# REQUEST FOR BIDS Operations Center Roof Replacement

Addendum #3

ADDENDUM 3 October 29, 2019

**Duluth Transit Authority Operations Center**

Details 3/A5 and 5/A6

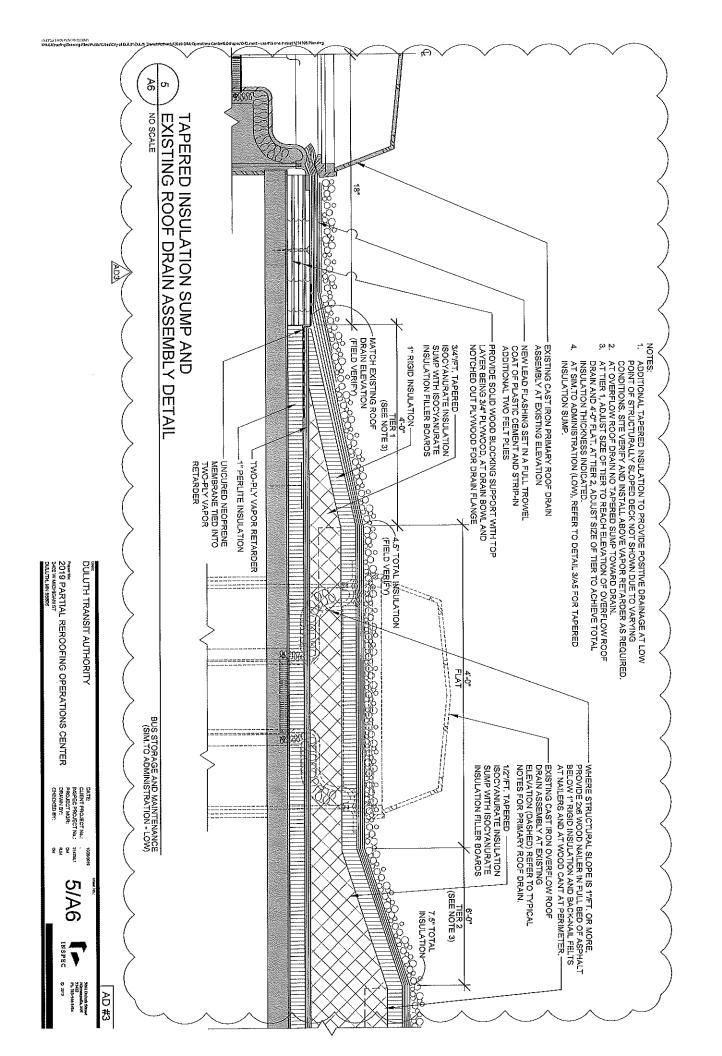
- 9. Detail 3/A5: Delete and replace with Detail 3/A5, attached
- 10. Add Detail 5/A6 Tapered Insulation Sump and Existing Roof Drain Assembly Detail

PARTIAL ROOF PLAN

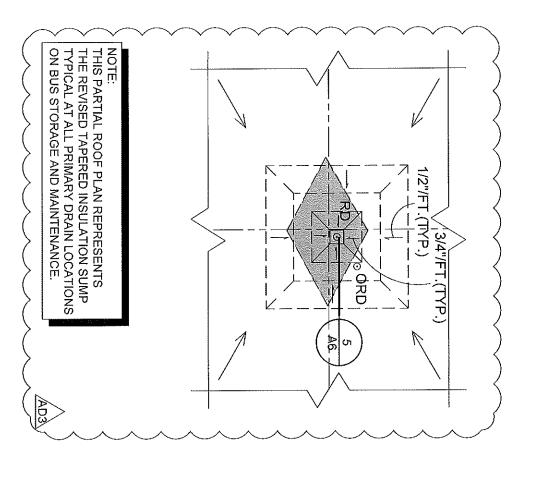
- 1. Sheet A1, Roof Plan, Administration (Low): Replace "RD" with "RD Sim To".
- 2. Sheets A1 and A1.1:
  - a. Roof Plans, Bus Storage, and Maintenance: Replace all tapered insulation sumps with tapered insulation sump indicated on the partial roof plan, attached.
  - b. Roof Plan Notations, "RD": Replace "Detail 3/A5" reference with "Detail 5/A6", and add "At RD Sim To location, refer to Detail 3/A5".
